# PERMIT

SEWAGE DISPOSAL SYSTEM  
HOWARD COUNTY HEALTH DEPARTMENT  
BUREAU OF ENVIRONMENTAL HEALTH

SUBDIVISION Monticello LOT NUMBER 39 ADDRESS 14321 Fox Creek Court

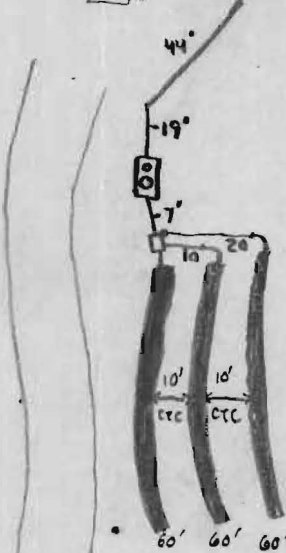
PRE-CONSTRUCTION INSPECTION: 7/31/01-SDA STAGED, INSTALL 3-60' TRENCHES TOWARDS RD,

STARTING 1ST TRENCH ON CONTOUR OUT OF SDA SLIGHTLY TO CONSERVE FUTURE REPAIR AREA, BUILDER MAY HAVE TO ADJ HOUSE SEWER BACK TO WHAT WAS APPROVED ON BP PLAN  
 INSPECTION COMMENTS: OR PUMP TANK MAY BE REQUIRED -SRW

8/16/01-OK TO COVER ALL WORK, HOLD FOR HOUSE CONN. -SRW 8-28-01 WPI DK KG

9/19/01-HOUSE CONN. VERIFIED OVER THE PHONE W/BUILDER -SRW
